RE: North Hardin High School
2007 Renovations
Radcliff, Kentucky

Contract Change Order

RE: North Hardin High School
Architect Project No. 0701
PFGW MOD. #1.1, 1.2 and 1.3 dated 6-8-07

REVISED HEAD DTL.

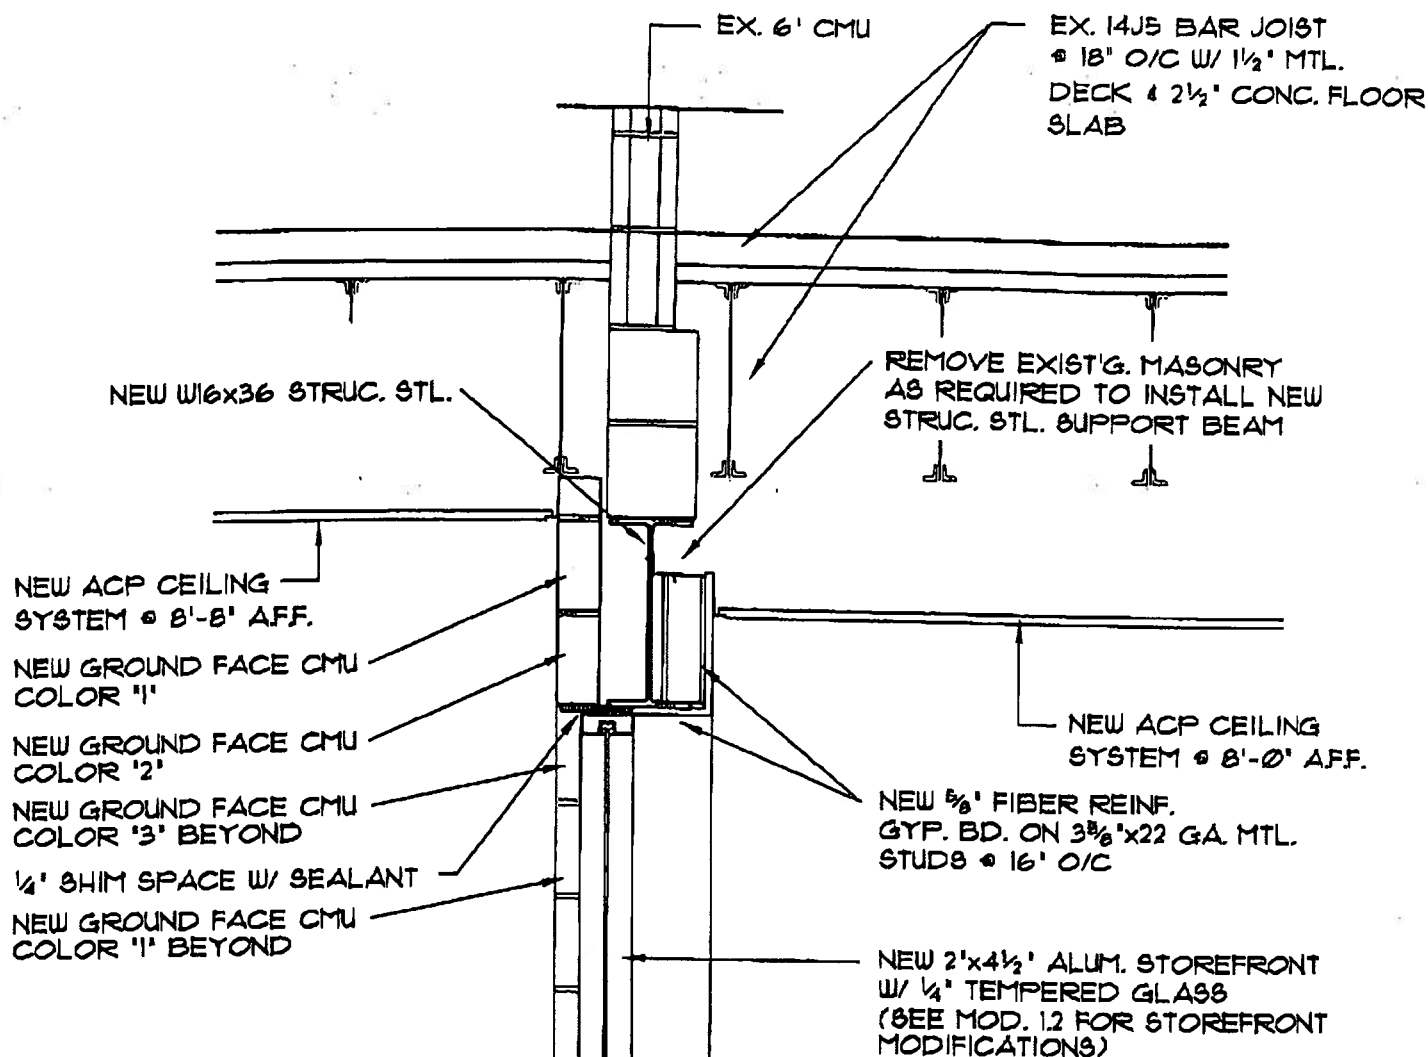
Don Taylor pointed out on site that the existing cmu wall is continuous thru the second floor to the roof. Tim Maurer and myself meet with Don Taylor on June 8, 2007 on site regarding the wall construction. Tim Maurer of MSE Structural Engineering has calculated the beam size required to span the new opening and carry the existing wall above.

Refer to the attached PFGW Mod. No. 1.1 and 1.2 drawings dated June 7, 2007 showing the installation of a W16x36 structural steel beam above aluminum storefront between Lobby #101 and Waiting #105.

STRUC. STL. BEAM DTL.

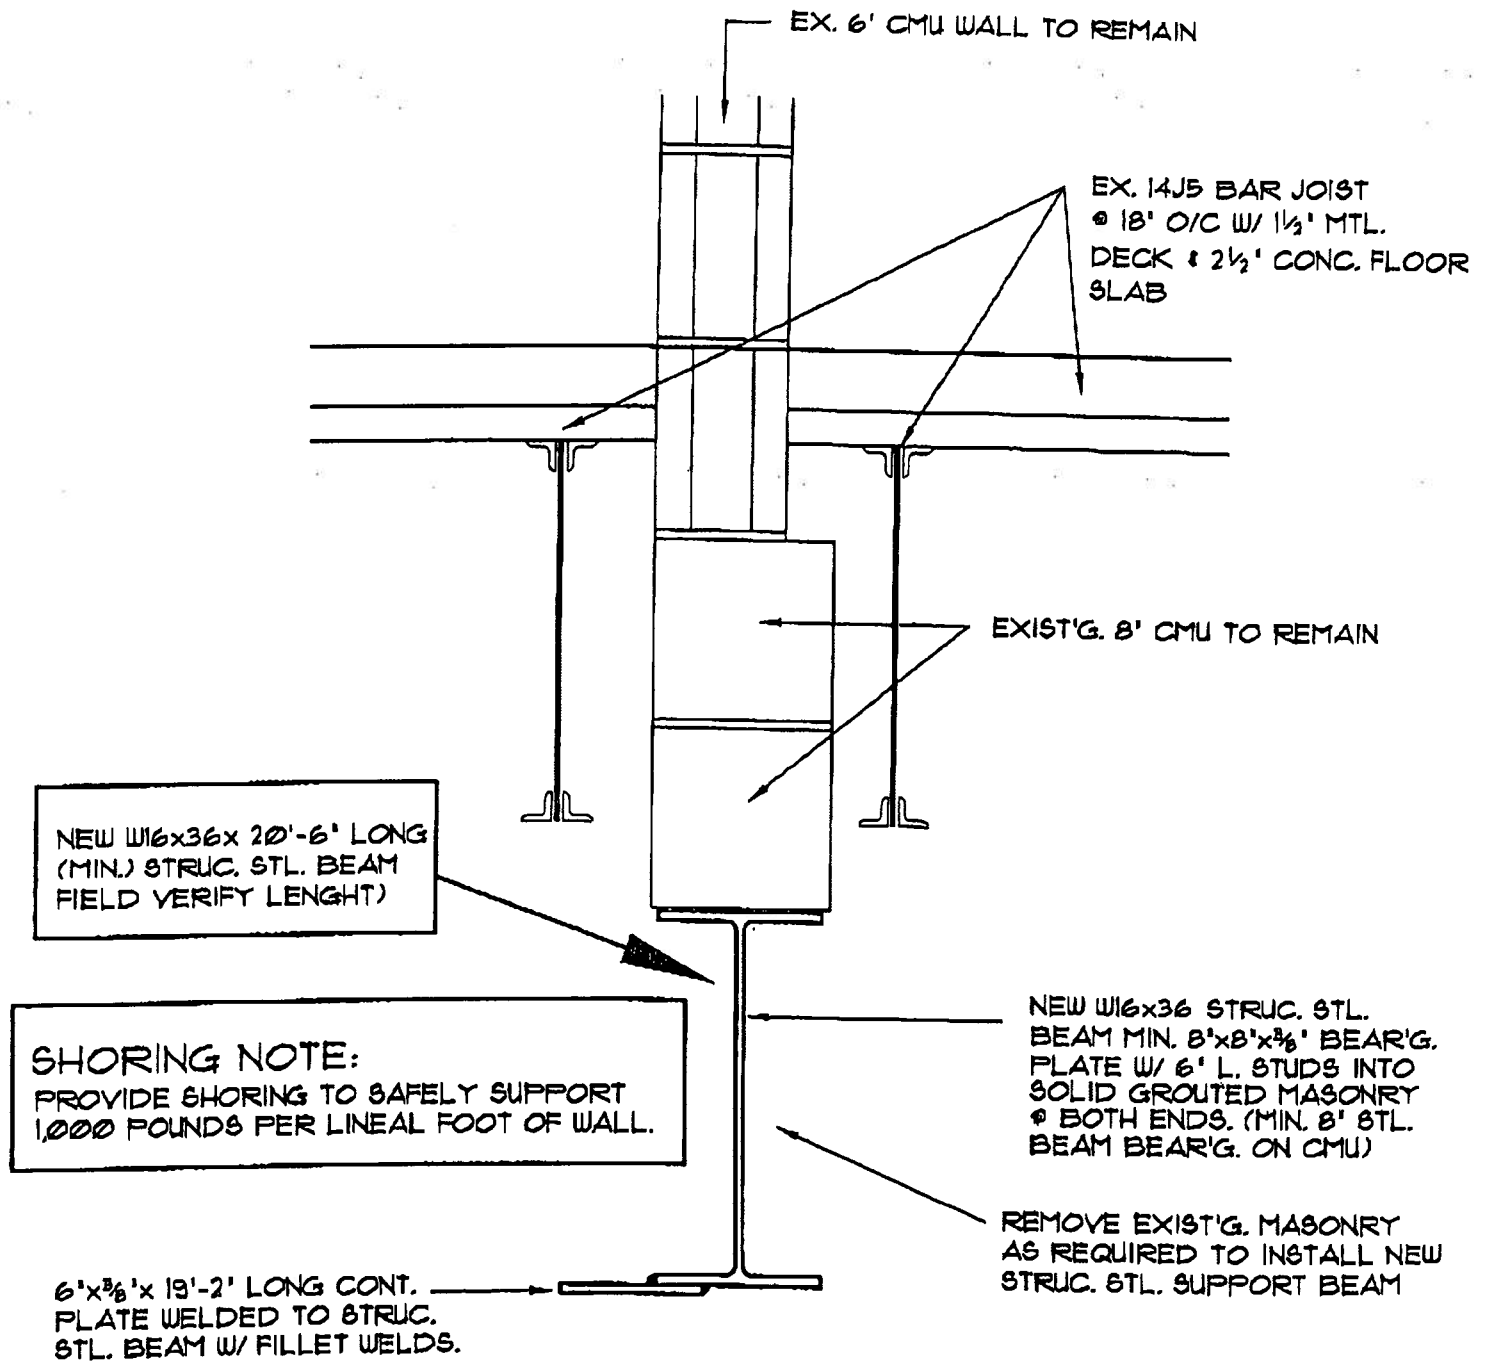
Comments: We propose to fabricate and deliver 1 – W16x36 beam lintel with a continuous bottom plate PL3/8"x6" along with 2 – bearing plates PL3/8"x8"x8" per MOD. 1.1 & MOD. 1.2 for a total of \$1,400. Installation of the beam lintel will cost an additional \$1,500. Please advise any further action. Thank you.

STOREFRONT MODIFICATIONS

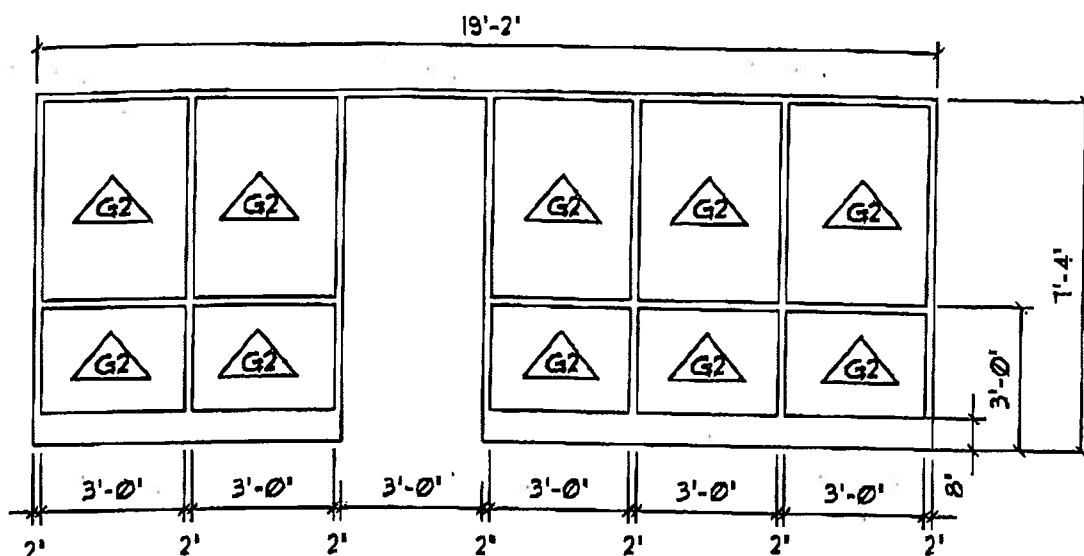
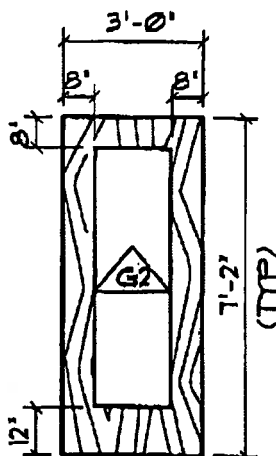
Aluminum Storefront "AL-4" and Wood Door Type "F" have been modified per Mod. 1.3. All 4" spandrel glass and associated aluminum framing has been eliminated.
